Proposal for corrigendum to Regulation No. 49

I. Proposal

“Figure 15

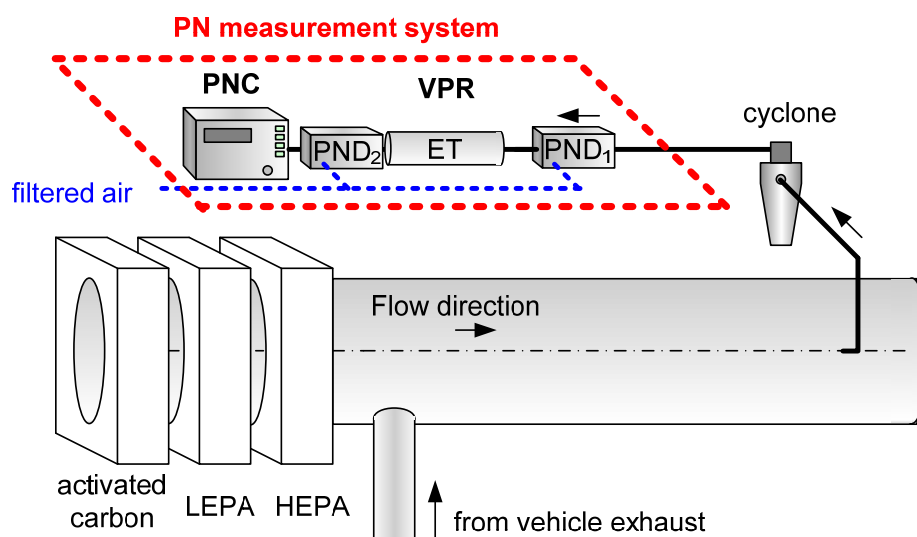
Annex 4C, Appendix 1, replace Figure 15 with the following:

WLTP DTP PM-PN subgroup discussions also identified an error in the particle number measurement diagram in Regulation 49, in that the sequence of dilution air filters was incorrect and at odds with the text of the Regulation. A corrected diagram was prepared for inclusion in the WLTP GTR. This informal document proposes to copy this corrected diagram into Regulation 49.
